PHASE 1 - SEQUENCE OF CONSTRUCTION

FRA-71-14.36

MAINTENANCE OF TRAFFIC - PHASE 1D
W. MOUND ST. - STA. 13+50 TO STA. 23+50

RETAINING WALL NOTES 5 OF 9
RETAINING WALLS
I-70/I-71 WEST INTERCHANGE PROJECT

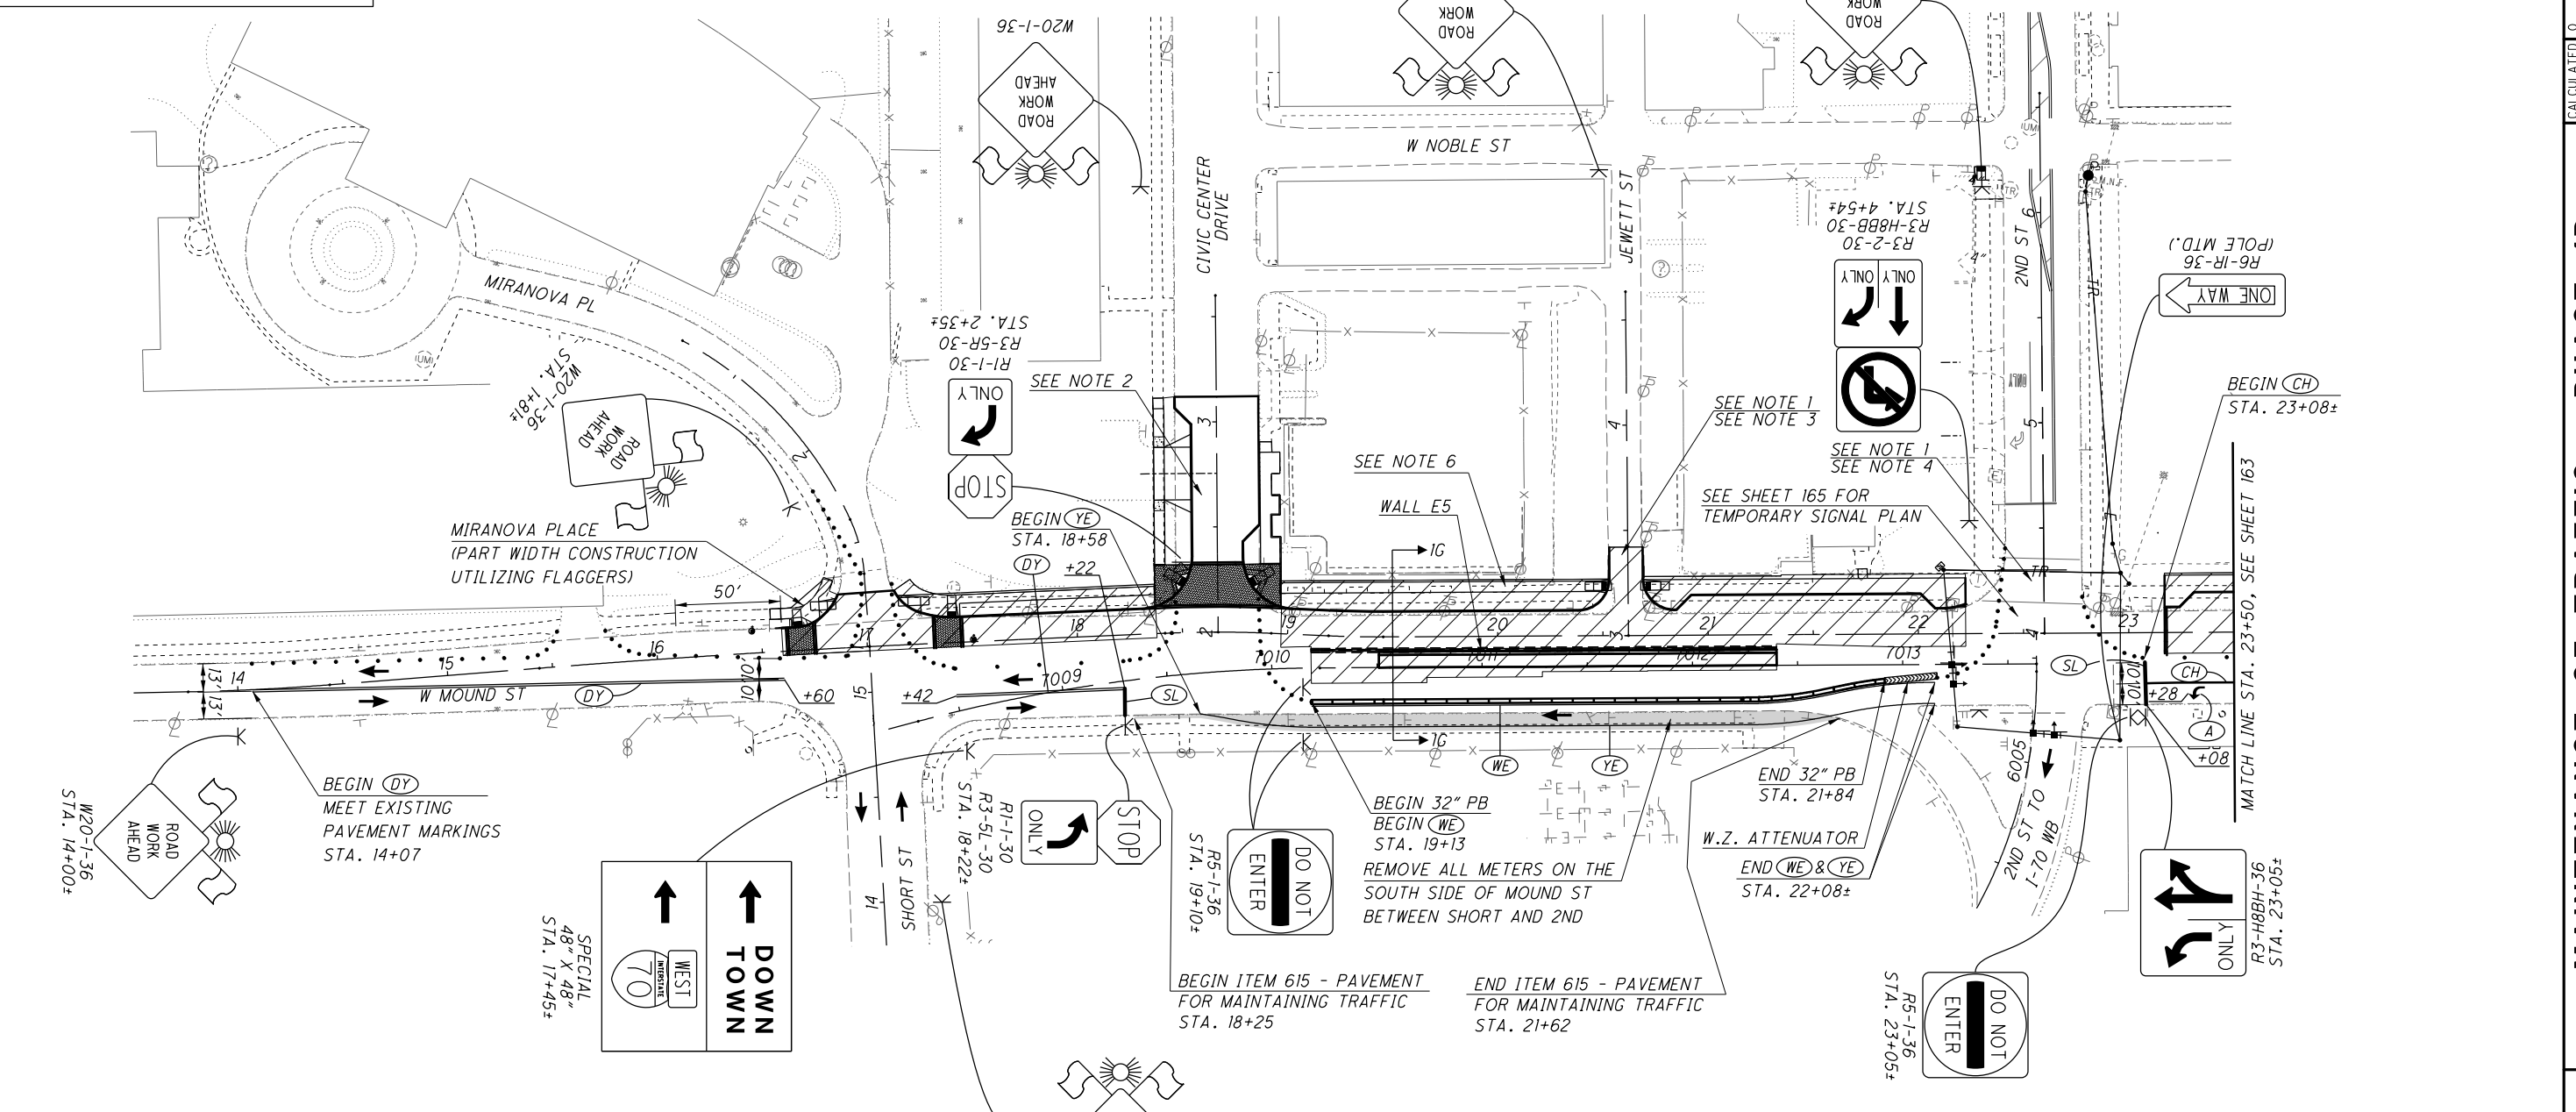
NO.	DESCRIPTION	REV. BY	DATE
9	MOUND ST 1-WAY WB	KWR	12-09-2021
10	SHIFT MOUND ST SOUTH	KWR	12-14-2021
